SEWAGE DISPOSAL TESTING

SUBDIVISION HEATHERWOOD LOT NO. 6

From: Oswald, Hank
Sent: Wednesday, March 02, 2016 9:50 AM
To: 'texasjeff10@gmail.com'
Subject: 13201 Old Frederick Road Septic Record
Attachments: A26895_03-307417_13201_OLD_FREDERICK_ROAD.pdf; Perc Test and Plan Requirements.pdf

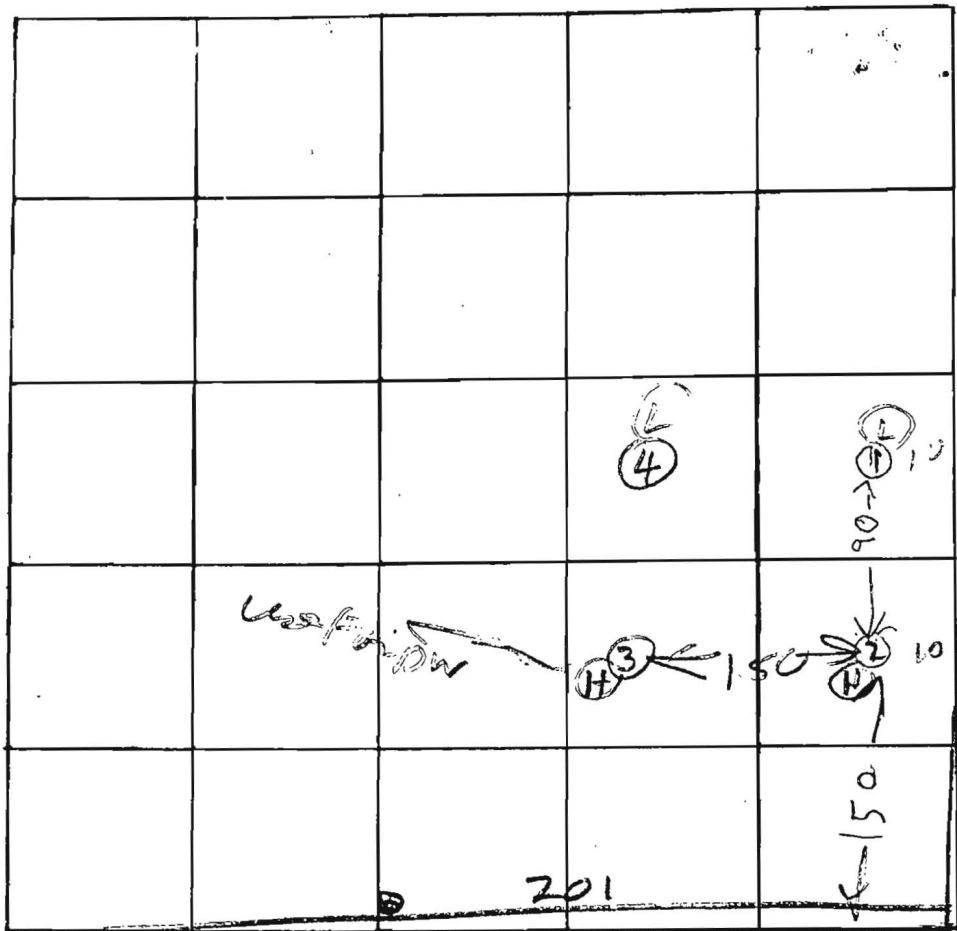
REASONS FOR REJECTION OR HOLDING 9/30/77 Per OK Hold for Plat
10/6/77 Held for Review with FIF Per OK (77)
